## V2500-A1 SERIES PROPULSION SYSTEMS SERVICE BULLETIN

This document transmits Revision 4 to Service Bulletin EV2500-72-0351

# V2500-ENG-72-0351

ENGINE - HP TURBINE ROTOR AND STATOR ASSEMBLY - INTRODUCE A NEW FIRST STAGE TURBINE  
AIR SEAL

Before and After views of configuration changes that effect the High Pressure Turbine Rotor and Stator Assembly  
Figure 1

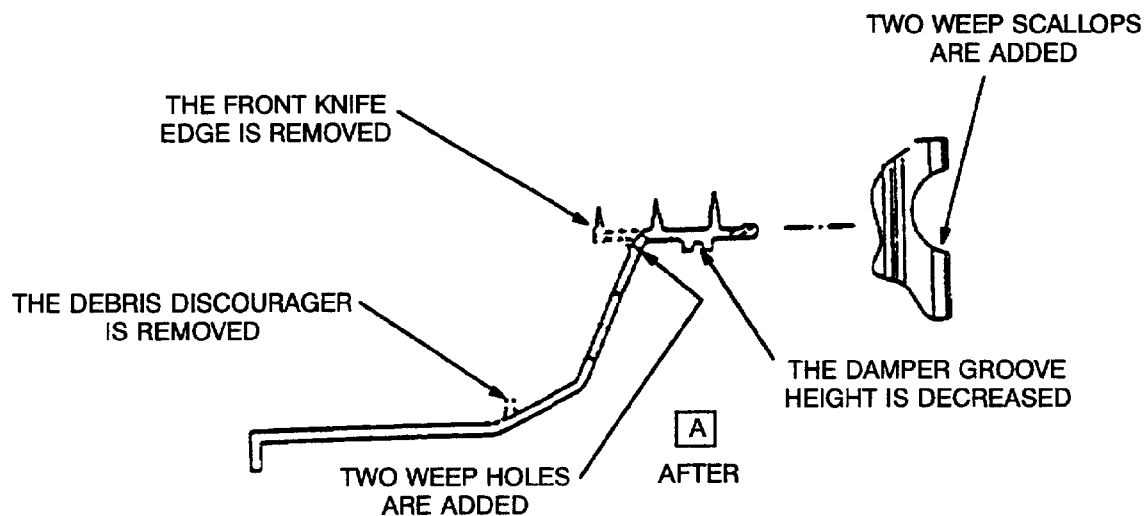
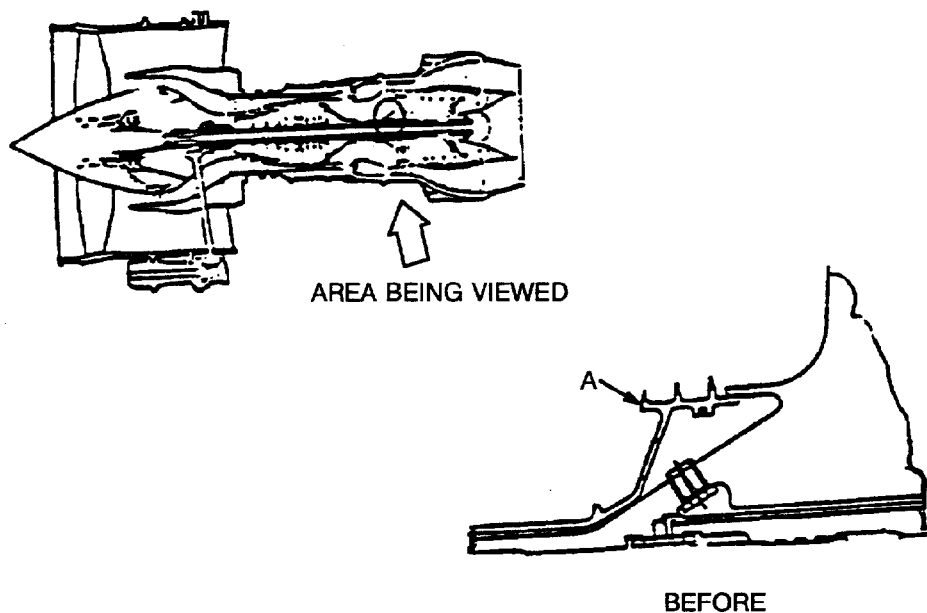
- (1) Improve the features of the air seal so that more of the unwanted oil will drain from the area between the air seal and Stage 1 Hub. See Figure 1.
- (2) For the effect on declared life, the Time Limits Manual, 5-10-01, Group A Parts Lives will be updated to include the following:

Location of the Stage 1 HPT Air Seal  
Figure 2

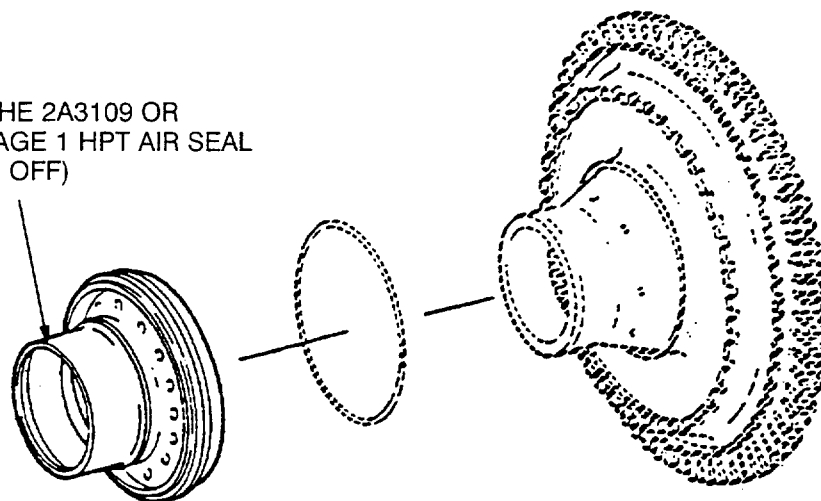
- (1) Install the 2A0884-001 or 2A3109 Stage 1 HPT Air Seal (1 off) by the approved procedure given in Reference (3), Chapter/Section 72-45-10 Assembly. See Figure 2.

INSTALL THE 2A3109 OR  
2A0884-001 STAGE 1 HPT AIR SEAL  
(1 OFF)

- (a) Cool the Stage 1 HPT Air Seal in dry ice before you install it.
  - (b) Use the IAE 1P16029 Drift to install the new Air Seal with the balance mark at the same location as the removed Stage 1 HPT Air Seal.
- (2) Identify the new rotor assembly as 2A2121-001 or 2A5201 by the procedure specified in Reference (2), Chapter/Section 70-09-00, Marking of Parts.
  - (a) Mark the new part number adjacent to the old part number.
  - (b) Use the vibration peen method.

Modification of the Stage 1 HPT Air Seal  
Figure 3 (Sheet 1)

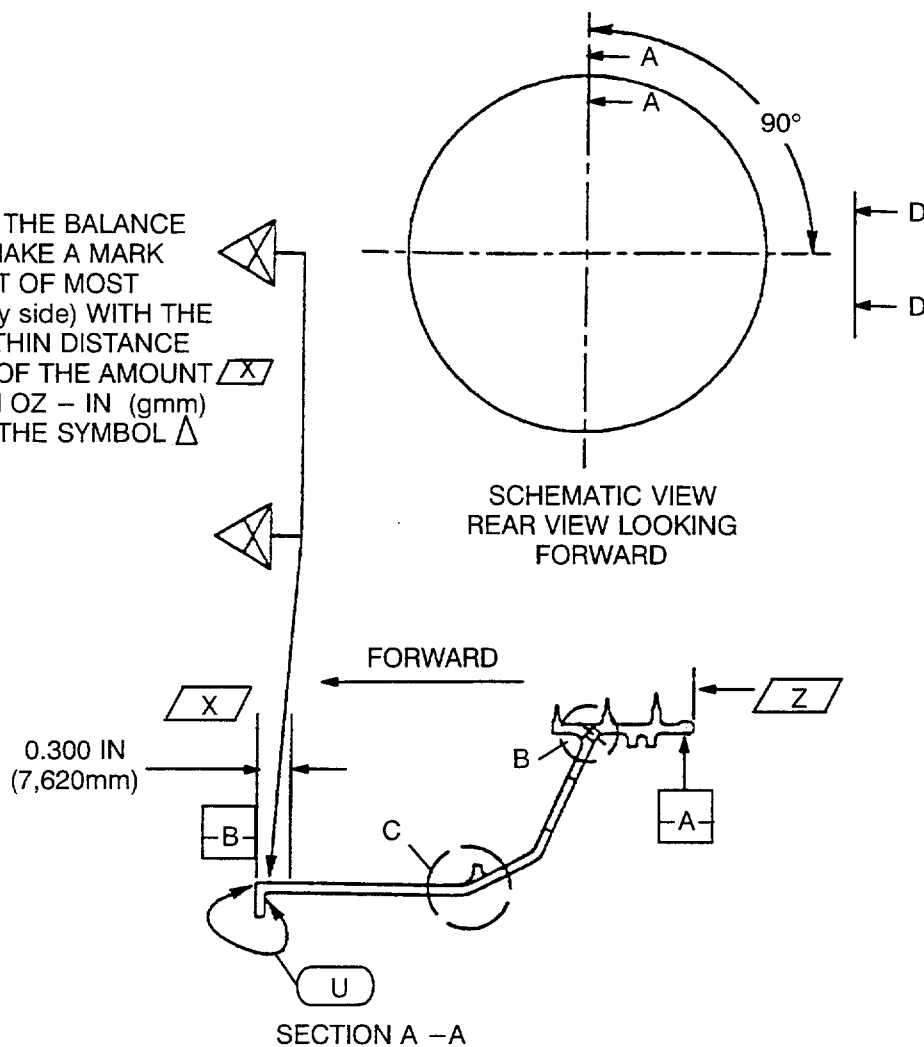
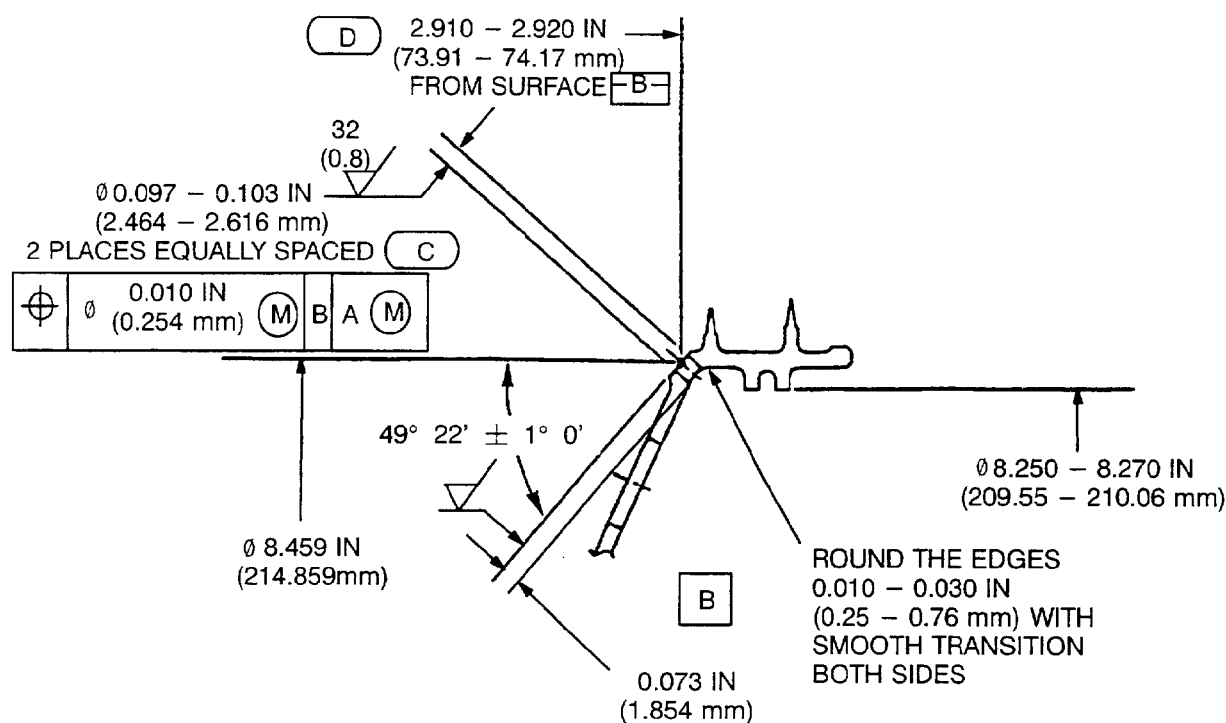
PROCEDURE	RELATED DATA
(1) Set up and machine to the dimensions specified	Refer to Figures 2 and 3.
(2) Machine to remove the front knife edge seal. Finish as specified	Refer to Figure 3. See Reference (2), Control No./Task No. 70-35-09-350-501.

- (3) Machine two holes at the locations given. Hold to the dimensions and finish as specified Refer to Figure 3. See Reference (2), Control No./Task No. 70-35-09-350-501.

- (8) Do a check of the static unbalance at 900 RPM with the part held on Refer to Figure 3.
- (9) Make a mark to show the location of the heavy point by the procedure specified. Use CoMat 06-072 Dye or the Vibration Peen method See Reference (2), Control No./Task No. 70-09-00-400-501

- (10) Mark the new part number adjacent to the old part number. Use the vibration peen method. Refer to Figure 3. See Reference (2), Control No./Task No. 70-09-00-400-501

DO A CHECK OF THE BALANCE  
AT 900 RPM. MAKE A MARK  
AT THE POINT OF MOST  
UNBALANCE (Heavy side) WITH THE  
SYMBOL  $\Delta$  WITHIN DISTANCE  
MAKE A RECORD OF THE AMOUNT  
OF UNBALANCE IN OZ - IN (gmm)  
ADJACENT TO THE SYMBOL  $\Delta$

Modification of the Stage 1 HPT Air Seal  
Figure 3 (Sheet 2)

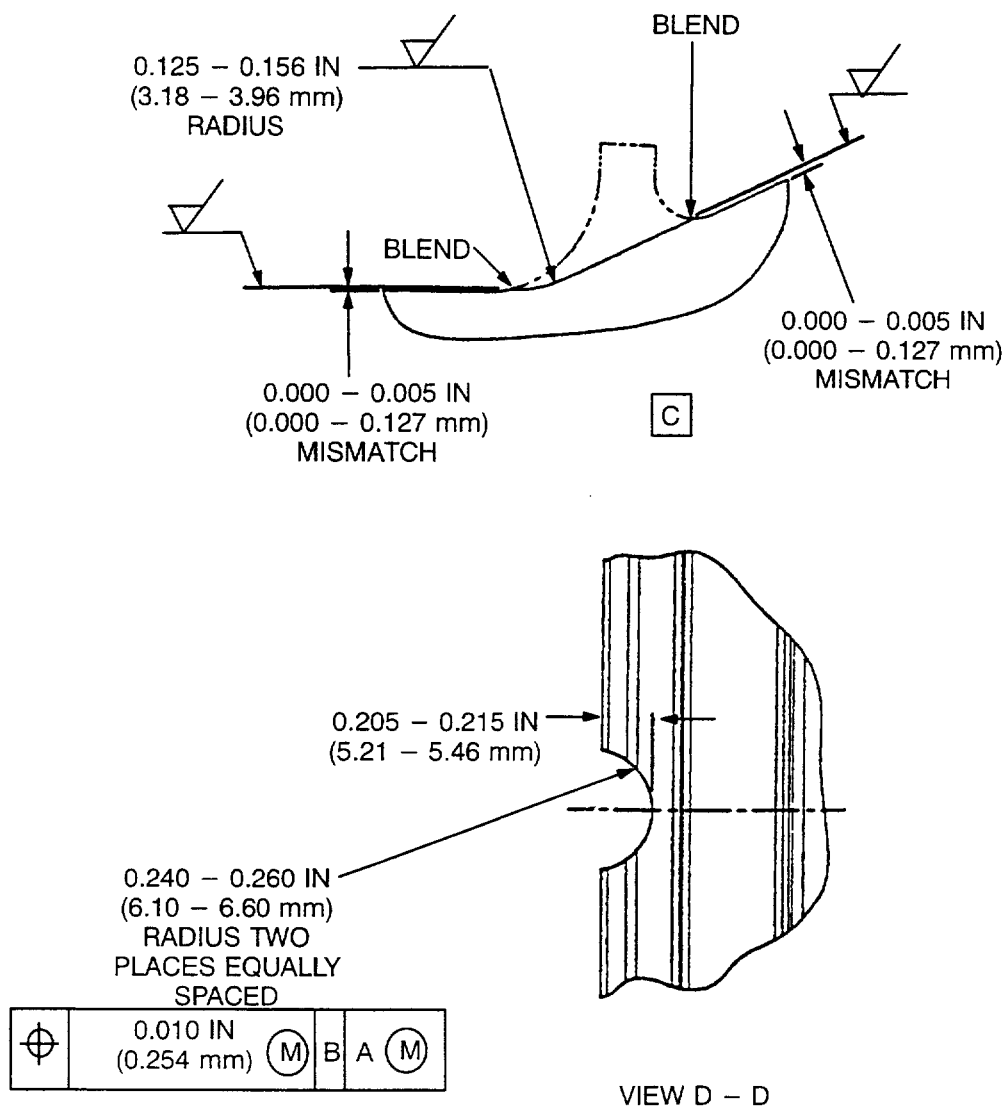
- (4) Machine the damper groove to the dimension specified Refer to Figure 3, Sheet 2.
- (5) Machine to remove the debris discourager. Hold to the dimensions and finish as specified. (PN 2A1203 only) Refer to Figure 3, Sheet 3, View C. See Reference (2), Control No./Task No. 70-35-09-350-501.
